Access Compliance Report

Public Rights-of-Way

Intersection ID: 11256	Main Street: 5TH_ST	Cross Street: IRWIN_RD	Location: W
ADA ID: C6815C59C051	Ramp Type: Directional1	Initial Pass/Fail: Pass	Overall Compliance: No
Severity Score: 0			
Codes/Mitigation Info/Possible Solution		Field Measurements/Component Compliance

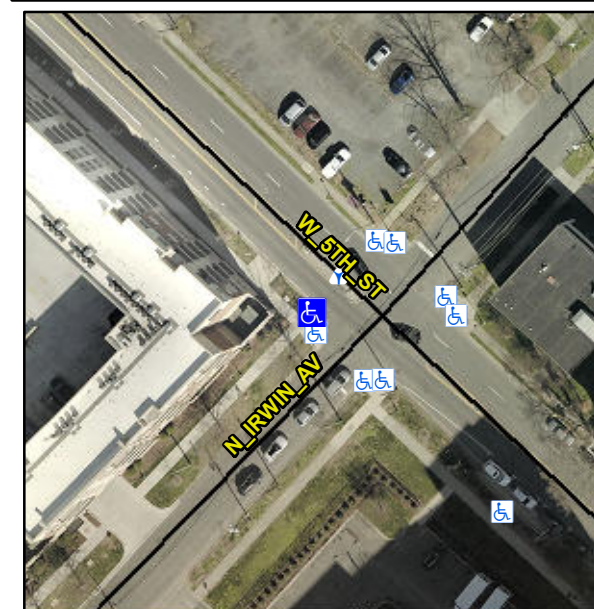
R304.5.3, R305.2

Compliance	Description	Data	Compliance	Description	Data
N/A	Ramp Length (in)	88.0	Yes	Grade Break?	Yes
Yes	Ramp Width (in)	70.0	No	Grade Break Slope (%)	7.0
Yes	Ramp Slope (%)	5.9	Yes	Grade Break XSlope (%)	0.9
Yes	Ramp XSlope (%)	0.3			
Yes	Flare Type LT	N/A	Yes	Flare Type RT	N/A
N/A	Flare Slope LT (%)	N/A	N/A	Flare Slope RT (%)	N/A
N/A	Flare Traversable LT?	No	N/A	Flare Traversable RT?	No
Yes	Landing Length (in)	72.0	Yes	DWS Provided?	Yes
Yes	Landing Width (in)	64.0	Yes	DWS Contrast?	Yes
Yes	Landing Slope (%)	0.2	Yes	DWS Length (in)	24.0
Yes	Landing X Slope (%)	1.2	Yes	DWS Full Width?	Yes
N/A	Landing Curb? (Y/N)	N/A	No	DWS Offset LT (in)	4.0
N/A	Shared Landing?	Yes	Yes	DWS Offset RT (in)	12.5
Yes	Gutter Ponding?	No	Yes	Gutter Slope (%)	2.7
Yes	Gutter Lip Ht (in)	0.0	Yes	Gutter X Slope (%)	0.7
N/A	Painted X Walk1?	No		Road Slope (%)	4.2
	X Walk 1 Direction	To NE		Road X Slope (%)	2.0
	X Walk 1 Width (in)	N/A		Clear Space?	Yes

Remove & Replace Entire Ramp.
